City of Oxford
Community Development Department
STAFF REPORT

Case # BZA-2017-08

Applicant:	Tommy Reed / Atlantic Sign Company
Location:	19 East High Street
Owner:	Uptown Investments LTD
Action Request:	Variance to Section 1151.05(a)2(B), variance to sign lighting requirements of the Uptown Zoning District
Current Use:	Commercial
Zoning:	UP (Uptown)
Surrounding Land Uses:	Retail, Multi-Family (Mixed Use), Public Park

City of Oxford
Community Development Department
STAFF REPORT

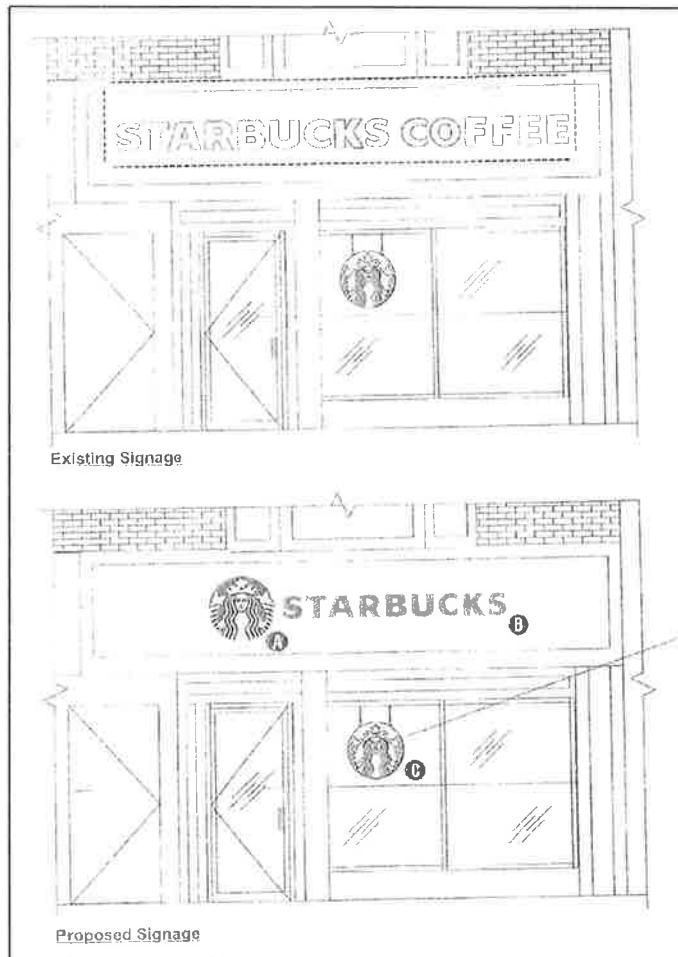
Tommy Reed of Atlantic Sign Company, on behalf of Starbucks, is seeking a variance from the sign lighting requirements of the Uptown Zoning District. Starbucks store is currently being remodeled and is proposing a new wall sign as part of the project. A reverse-lit wall sign is proposed, which is not permitted by the Oxford Zoning Code for this store located in the Uptown District. To the right is a drawing showing the previous and proposed wall signs.

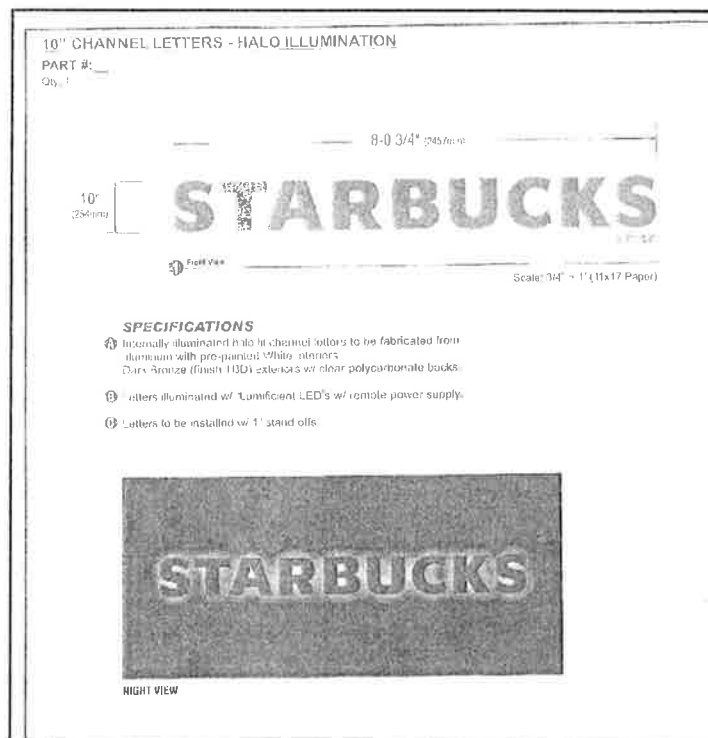
The proposed sign is considered being a reverse, “halo”, illumination by the sign industry.

Pictured below is an excerpt of the proposed sign plans showing the ‘halo’ or ‘reverse’ lighting effect.

Technically, as the Petitioner indicated in his narrative, that the proposed sign is a direct illumination. The proposed signage does not fit the narrowly-prescribed definition of direct illumination. Nor does the sign fit the definition of indirect illumination. As the sign industry continues to evolve to newer products and newer technology, the definition of the Oxford Zoning Code remains to be static as written in 2005. The proposed sign is considered a reverse, “halo” illumination that is not entirely enclosed within the sign and can be visible from outside of the sign. The proposed sign also technically fits into the description of direct illumination. It may be a commonly seen signage for the business in the Uptown District, but the source of illumination is toward the sign and the beam of light falls on the exterior surface of the sign.

10" CHANNEL LETTERS - HALO ILLUMINATION

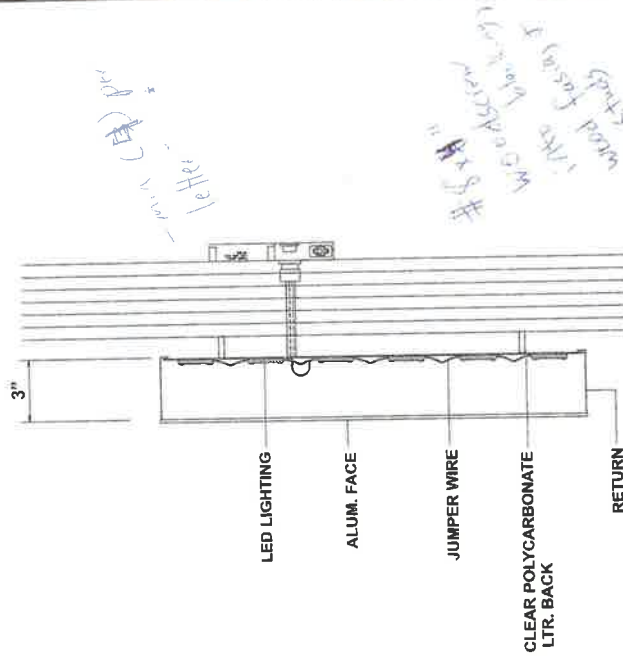
The proposed sign includes LED lighting from behind the sign lettering, which is not a permitted type of lighting per the Oxford Zoning Code.

Pictured above is the site plan submitted with this variance request.

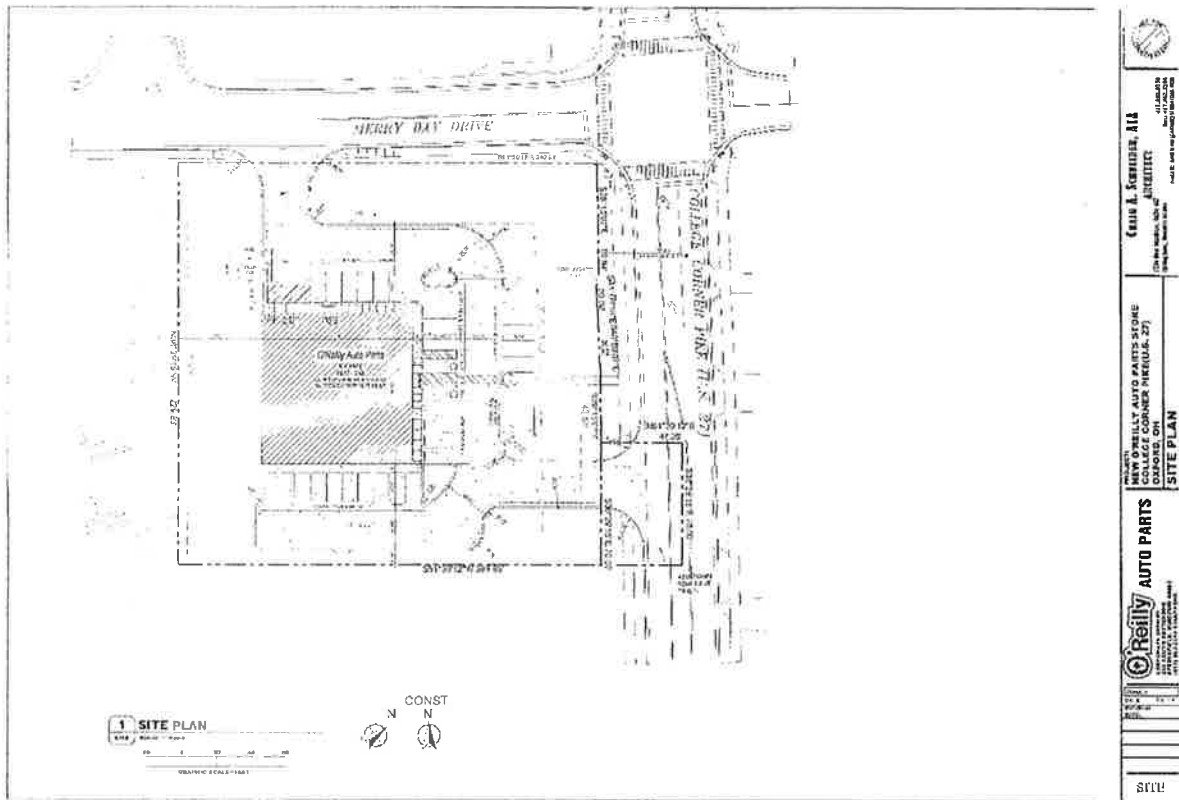
Oxford Zoning Code Section 1149.05(a)3 limits the number of parking stalls in front of the principal structure to no more than 70% of the minimum number of required parking stalls. In this case, the minimum number of required parking stalls is 25; therefore no more than 17 are permitted in front of the principal structure. The proposal is to have 25 stalls, which exceeds the limit by 8.

The site has two street frontages: College Corner Pike and Merry Day Drive, so there are two fronts that would count the number of parking in front of the principal building. The site provides the business exposure for the retail due to the corner lot, but it also creates difficulties to conform to the regulations.

1. **Parking location.** Section 1149.05(a)3 limits the maximum total number of off-street parking spaces provided in front of the principal structure to 70% of the total number of required off street spaces. The plan shows 150% of the required parking in front of the principal structure.
